Subject: Response to Requests for Additional Information on Topical Report
CENPD-404-P, Rev. 0
(Contains Proprietary Information)

Enclosure 1-P provides responses to the NRC's Requests for Additional Information (RAIs) on CENPD-404-P, Rev. 0, "Implementation of ZIRLO™ Cladding Material in CE Nuclear Power Fuel Assembly Designs." Each RAI is stated in its entirety followed by Westinghouse's response. Enclosure 1-P thus documents the formal set of RAIs to which Westinghouse is responding.

QUESTIONS ON CENPD-404-P ZIRLO™ CLADDING IN CE FUEL ASSEMBLY DESIGNS*

Figure 3.4-2 ZIRLO Measured Oxide Thickness vs. Modified Fuel Duty Index

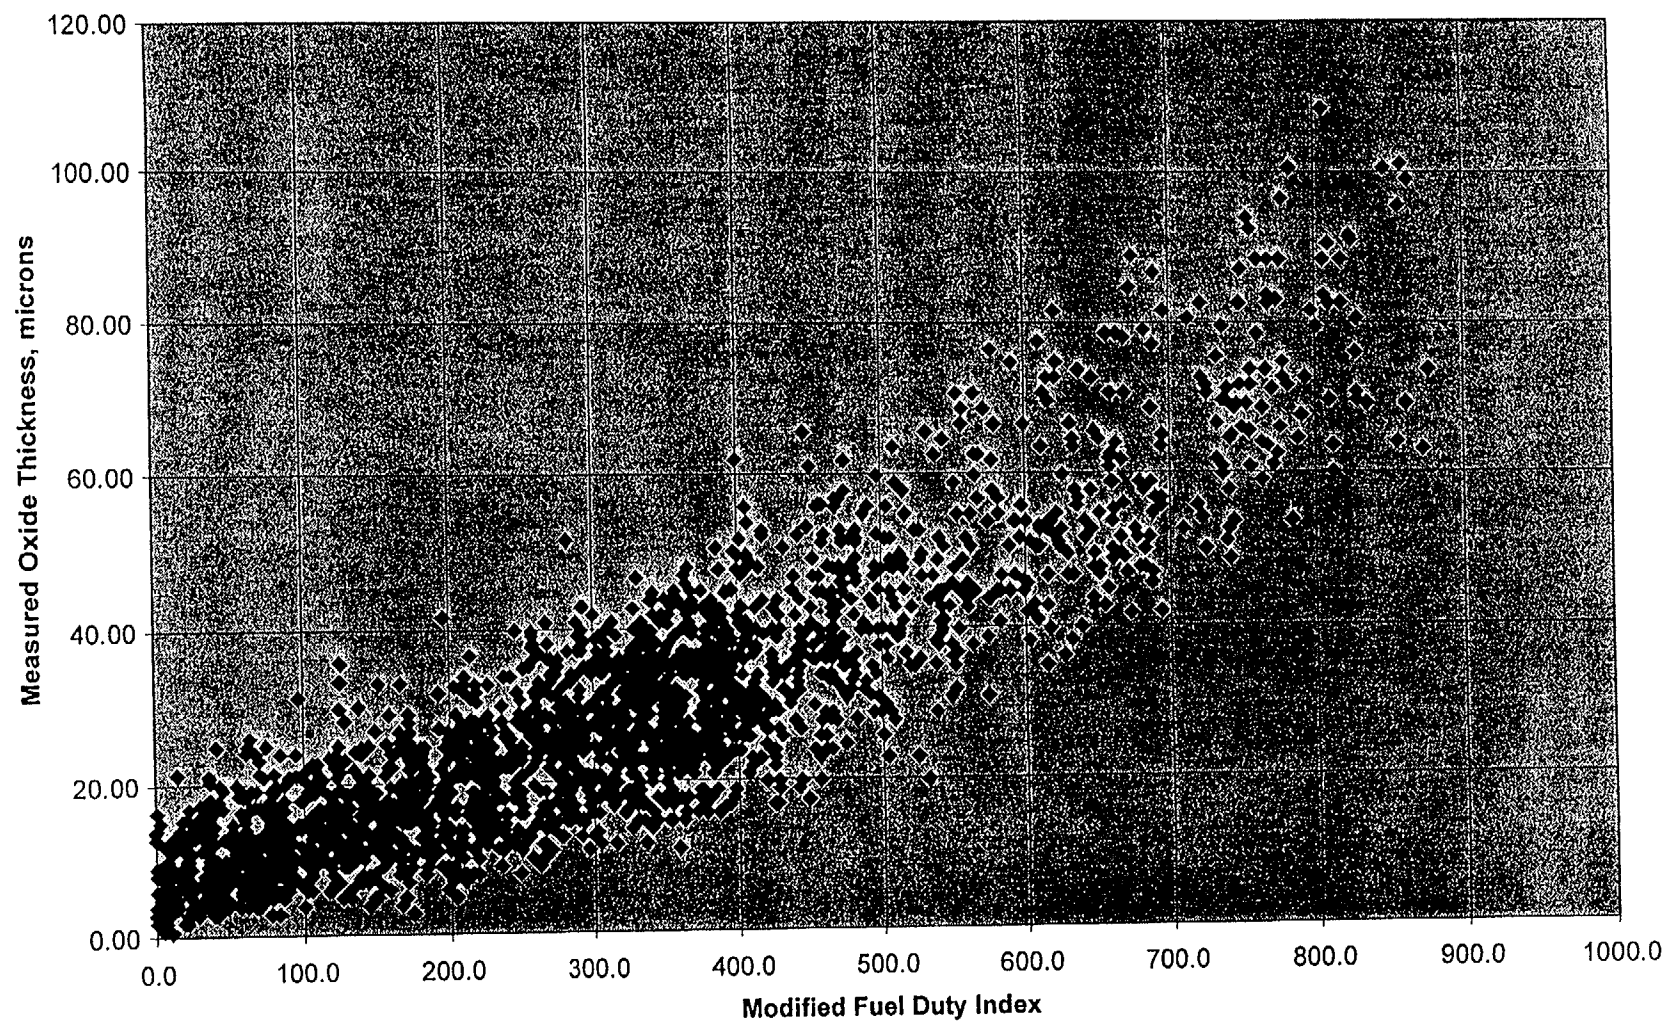
Figure 3.4-2 on page 18 of CENPD-404-P, shows modified fuel duty index vs. measured oxide thickness. Please provide the details of the measurements shown. Will the CE plants limit fuel duty index until actual corrosion data is obtained for ZIRLO™ in CE plants?

Table 1-1 provides a summary of the fuel rods for the ZIRLO™ corrosion database shown in CENPD-404-P Figure 3.4-2. For each fuel rod, a modified Fuel Duty Index (mFDI) was calculated at the location of the measured maximum oxide thickness in each grid span. Therefore, for a given fuel rod several points may be plotted in Figure 3.4-2 based on the number of grid spans measured for oxide thickness. The mFDI model is described in CENPD-404-P Section 3.4 and in the response to Question 11.

Westinghouse's current calculations show that the maximum mFDI experienced to date for CE designed 14x14 and 16x16 fuel is well within the ZIRLO™ database defined in Figure 3.4-2. Typical maximum mFDI values given in CENPD-404-P Section 3.5 are [] for 14x14 fuel and [] for 16x16 fuel. These maximum mFDI values are not operating limits but were calculated to demonstrate where CE designed fuel falls within the ZIRLO™ database for Westinghouse designed fuel. The engineering implementation of ZIRLO™ cladding for CE designed fuel will demonstrate that the mFDI and best estimate oxide thickness stays within the bounds of the ZIRLO™ database defined in Figure 3.4-2.

Oxide thickness will be measured on selected rods with the highest mFDIs to assure that actual corrosion performance is following the expected behavior shown in Figure 3.4-2. These measurements will be made on typical high duty fuel assemblies after second and third cycles of operation. For the initial batch implementation of ZIRLO™ the mFDI will be restricted until further data is obtained to verify corrosion performance. The interim mFDI restriction will be set so there is adequate corrosion margin with the use of ZIRLO™ compared to the use of OPTIN cladding and there is sufficient margin in the mFDI restriction to accommodate for uncertainties in core design (e.g. cycle length, plant operating conditions, etc). The mFDI restriction will be established by each licensee and addressed in the site specific submittal to implement the ZIRLO™ topical. The interim fuel duty restriction will be dropped or modified after measurements are obtained. The mFDI model may also be modified to assure accurate behavior for future fuel duty predictions after data is obtained.
